NO.	DATE	DESCRIPTION	BY	APP.
2	7/1/19	PCO #30 STREETLIGHT SERVICE	ST	SL
1	2/5/19	PCO #28 FURNISHING ZONE CHANGES	ST	SL

2ND STREET STREETSCAPE IMPROVEMENTS PROJECT

STREET LIGHTING PLAN
2ND STREET
BRYANT STREET TO BRANNAN STREET

CONTRACT NO. 1064J
DRAWING NO. E-4.0
FILE NO. 106,289
REV. NO. 2

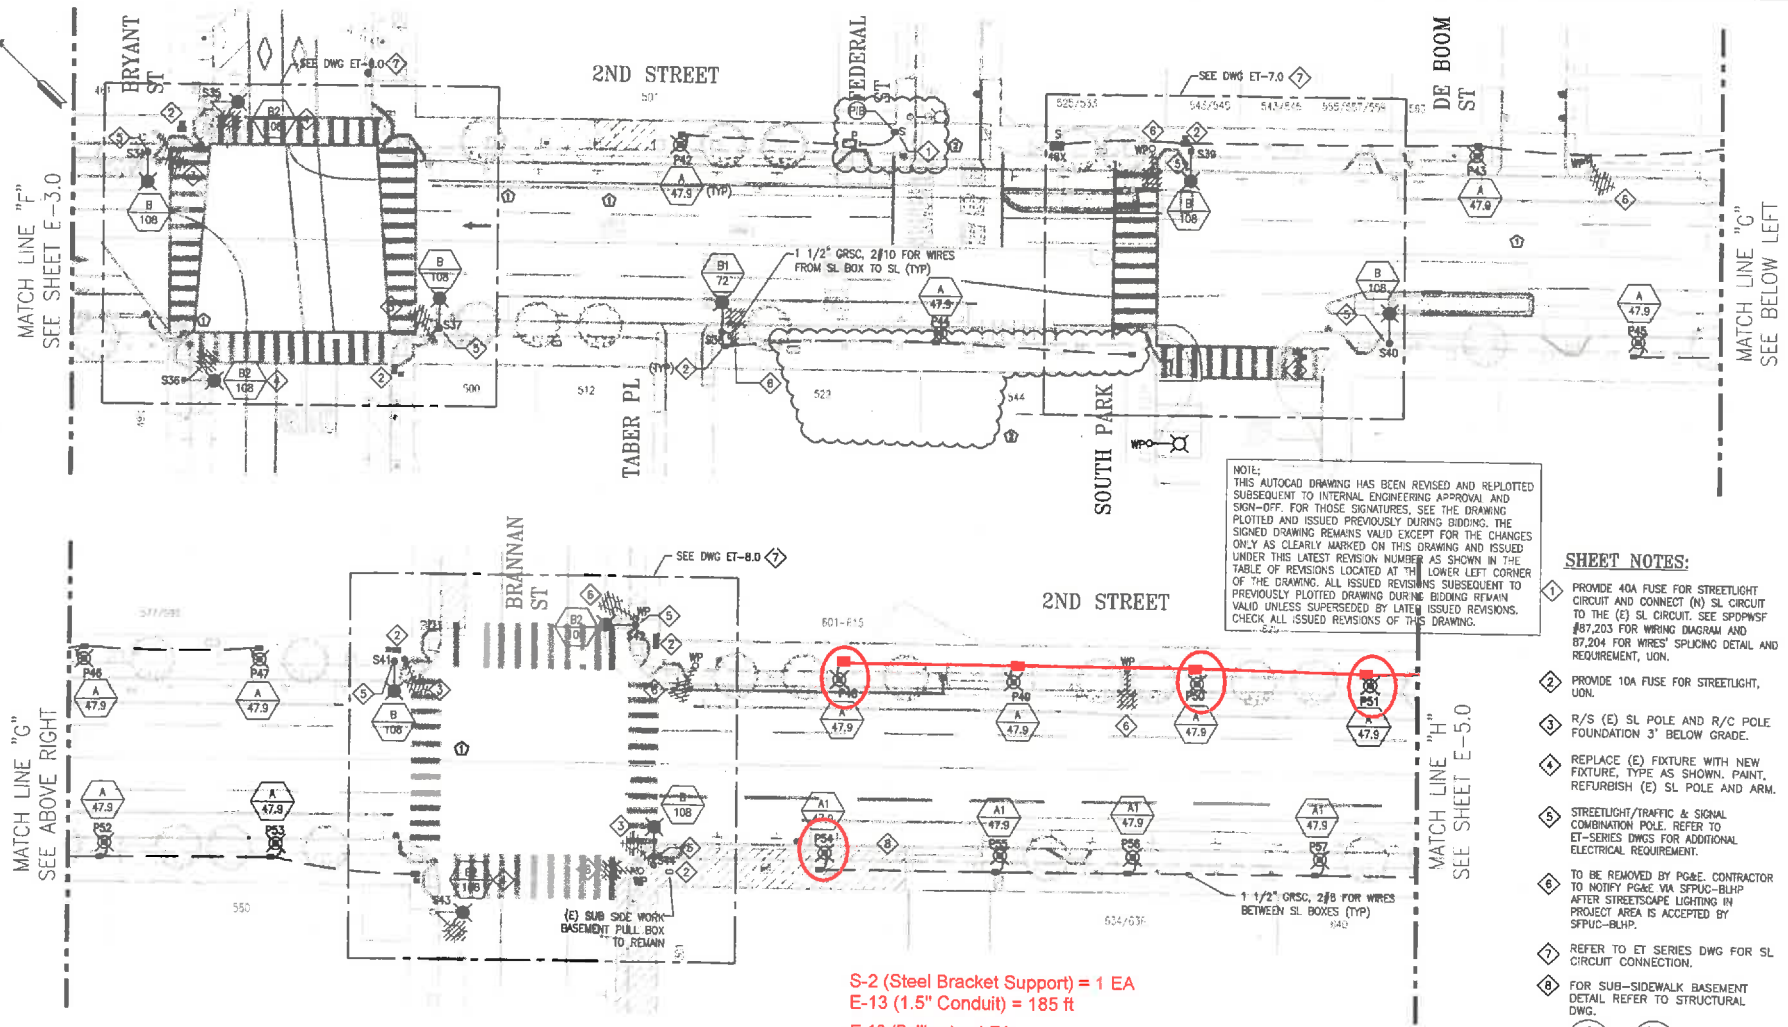
1. PROVIDE 40A FUSE FOR STREETLIGHT CIRCUIT AND CONNECT (N) SL CIRCUIT TO THE (E) SL CIRCUIT. SEE SPDPWSF #87,203 FOR WIRING DIAGRAM AND 87,204 FOR WIRES' SPLICING DETAIL AND REQUIREMENT, UON.
2. PROVIDE 10A FUSE FOR STREETLIGHT, UON.
3. R/S (E) SL POLE AND R/C POLE FOUNDATION 3' BELOW GRADE.
4. REPLACE (E) FIXTURE WITH NEW FIXTURE, TYPE AS SHOWN. PAINT, REFURBISH (E) SL POLE AND ARM.
5. STREETLIGHT/TRAFFIC & SIGNAL COMBINATION POLE. REFER TO ET-SERIES DWGS FOR ADDITIONAL ELECTRICAL REQUIREMENT.
6. TO BE REMOVED BY PG&E. CONTRACTOR TO NOTIFY PG&E VIA SFPUC-BLHP AFTER STREETSCAPE LIGHTING IN PROJECT AREA IS ACCEPTED BY SFPUC-BLHP.
7. REFER TO ET SERIES DWG FOR SL CIRCUIT CONNECTION.
8. FOR SUB-SIDEWALK BASEMENT DETAIL REFER TO STRUCTURAL DWG.
